**Draft Amendment C244melt
Referral 12 – Melton East Precinct Structure Plan and
Infrastructure Contributions Plan**

VPA Projects Standing Advisory Committee Report

Melton Planning Scheme Draft Amendment C244melt

Referral 12 – Melton East Precinct Structure Plan and Infrastructure Contributions Plan

Figure 15 Mathios evidence waterways & drainage (DSS) mapping - PSP Plan 7 Water

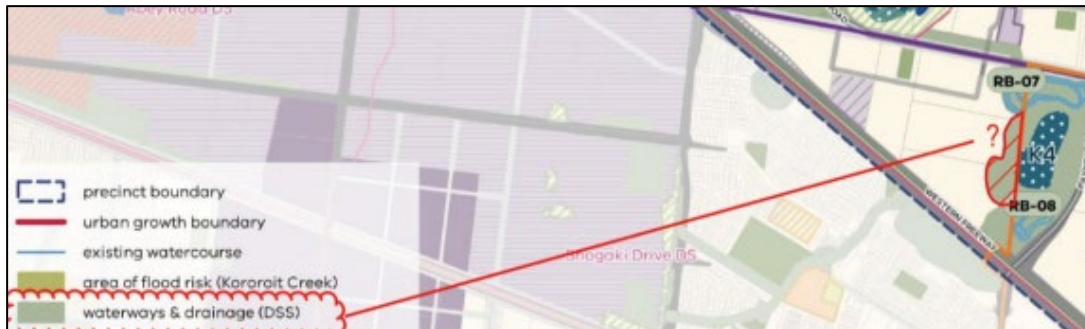
Mr Mathios proposed RB-07 be relocated to a narrower, lower lying area in the northeast of parcel 70. While the Day 1 PSP had supported this approach the hatched area shown in Figure 15 should not be designated as 'waterways & drainage (DSS)' but be included in the NDA.

Figure 16 Pre-development maximum 1% AEP flood depths

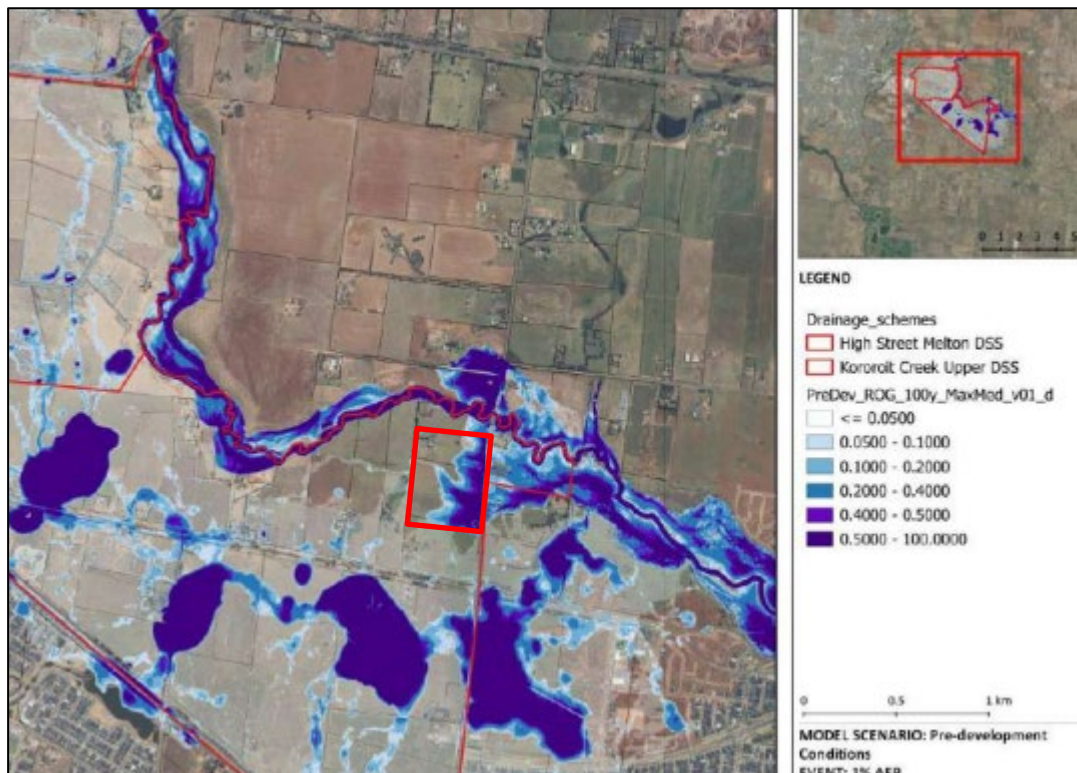
Mr Matheson considered the extent of flood risk in the PSP was inconsistent with the FDR predevelopment maximum 1% AEP flood depths (D150a) for parcels 59 and 60. This mapping showed around 54 per cent of the subject land impacted by the pre-developed 1% AEP storm event which included areas of shallow depth (Figure 16). His evidence, adopting the FDR mapping, included a schematic for a 4.8 ha retarding basin and wetland with flood offset storage which he recommended be investigated to potentially provide 13.08 ha of additional NDA on parcels 59 and 60 and service other adjacent land and provide further NDA opportunities.

Figure 19 Walsh evidence alignment changes to Tarletons Road

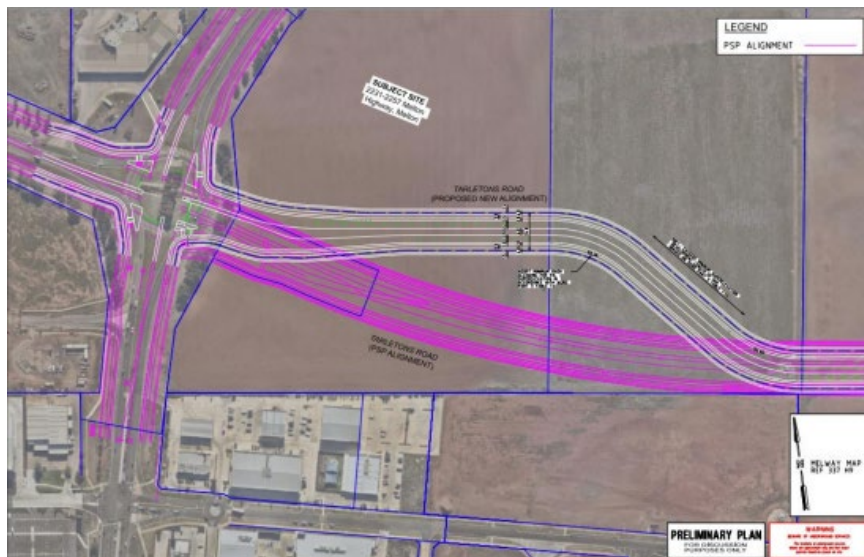
- Tarletons Road (RD-02-01) between Melton Highway and Mt Cottrell Road be shown as a secondary road within a 34 metre wide reservation with construction of a single carriageway in each direction (interim treatment)
- the Day 1 cross sections for the six lane arterial and the four lane arterial, but these could be refined further by replacing a two-way bike path on one side with a shared path or standard footpath
- the interim arrangement for IN-04 require the construction of a fourth leg to the existing roundabout, inclusive of pedestrian operated signals on the new leg, and the ICP Table 5 be amended to correctly identify the interim requirements
- an alternative alignment for Tarletons Road at its western end be adopted where it meets the existing roundabout (IN-04) (refer Figure 19).
